Access Compliance Report

Public Rights-of-Way

(Curb Ramps)

Intersection ID: N/A	Main Street: MATTHEWS_FARM_LN	Cross Street: N/A	Location: NW
ADA ID: 260EADC9181D	Ramp Type: Perp	Initial Pass/Fail: Fail	Overall Compliance: No
Severity Score: 13.75			
Codes/Mitigation Info/Possible Solution		Field Measurements/Component Compliance

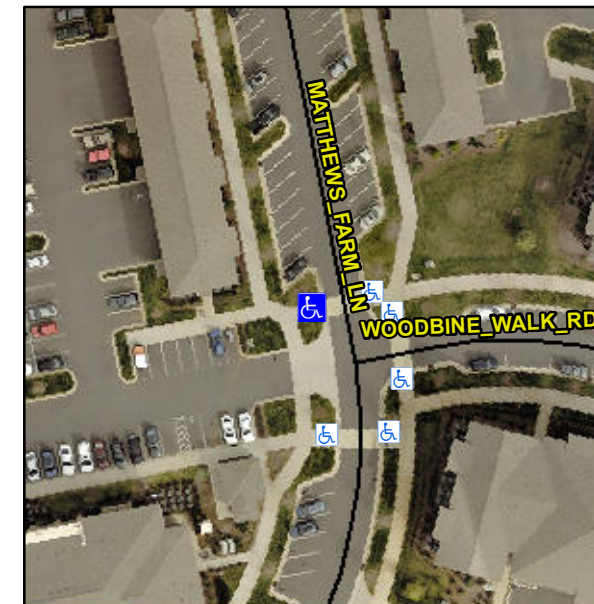
R304.2.2, R304.5.3

Compliance	Description	Data	Compliance	Description	Data
N/A	Ramp Length (in)	120.0	No	Ramp Slope (%)	9.7
Yes	Ramp Width (in)	93.0	No	Ramp XSlope (%)	2.6
N/A	Flare Type LT	N/A	N/A	Flare Type RT	N/A
N/A	Flare Slope LT (%)	N/A	N/A	Flare Slope RT (%)	N/A
N/A	Flare Traversable LT?	N/A	N/A	Flare Traversable RT?	N/A
N/A	Landing Length (in)	N/A	N/A	DWS Provided?	N/A
N/A	Landing Width (in)	N/A	N/A	DWS Contrast?	N/A
N/A	Landing Slope (%)	N/A	N/A	DWS Length (in)	N/A
N/A	Landing X Slope (%)	N/A	N/A	DWS Full Width?	N/A
N/A	Landing Curb? (Y/N)	N/A	N/A	DWS Offset (in)	N/A
N/A	Shared Landing?	N/A			
N/A	Gutter Ponding?	N/A	N/A	Gutter Slope (%)	N/A
N/A	Gutter Lip Ht (in)	N/A	N/A	Gutter X Slope (%)	N/A
N/A	Painted X Walk1?	No	N/A	Painted X Walk2?	N/A
	X Walk 1 Direction	To E		X Walk 2 Direction	N/A
N/A	X Walk 1 Width (in)	N/A	N/A	X Walk 2 Width (in)	N/A
	X Walk 1 Slope (%)	0.7		X Walk 2 Slope (%)	N/A
	X Walk 1 X Slope (%)	2.0		X Walk 2 X Slope (%)	N/A

Remove & Replace Entire Ramp.
